Product Change Notification: DSNO-04BWYN422

CCB 8227 Initial Notice: Qualification of Matte Sn as a new lead plating for MIC33153-4YHJ-TR, MIC33153YHJ-TR, MIC3385-1.5YHL-TR and MIC3385YHL-TR catalog part numbers (CPN) available in 14L TDFN (3.5x3.0x1.15mm) and 14L VDFN (3.5x3.0x1.15mm) packages at UNIS assembly site.

CCB 8227
Pre and Post Change Summary
PCN #: DSNO-04BWYN422

Lead-Frame Comparison

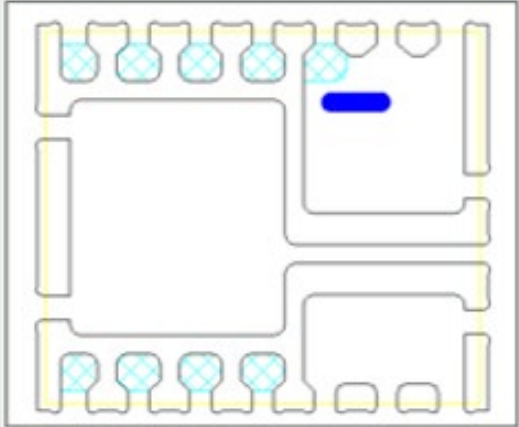
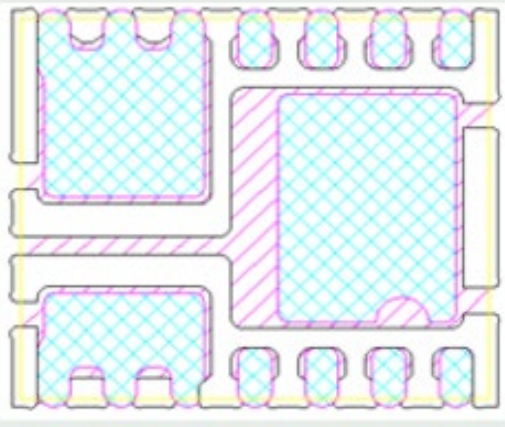
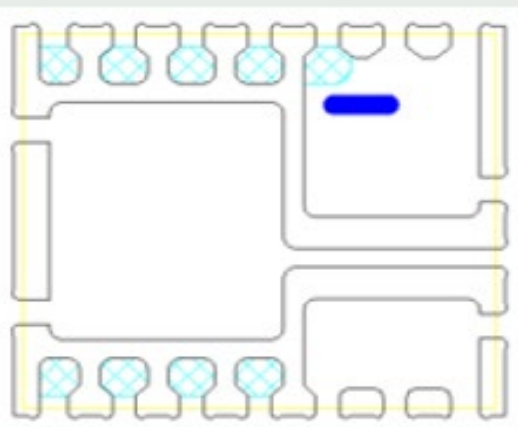
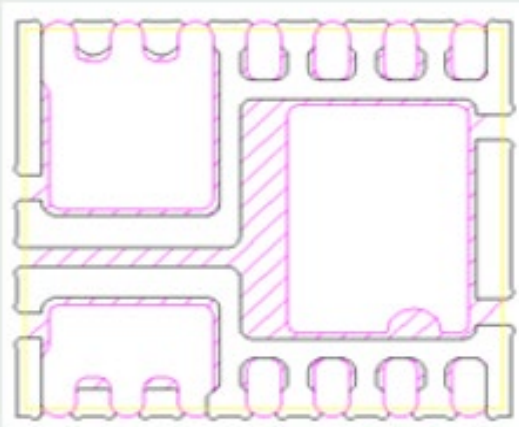
Pre Change		Post Change	
Top view (selective PPF)	Bottom view (selective PPF)	Top view (selective Ag)	Bottom view (Cu)

Lead-Frame Material	A194FH	Lead-Frame Material	A194FH
Lead-Frame Lead Plating Material	NiPdAu	Lead-Frame Lead Plating Material	Matte Sn

***Note 1:** Leadframe Top side change from “Selective PPF” to “Selective Ag Plating”; Bottom side change from “Selective PPF” to “Bare Cu”.
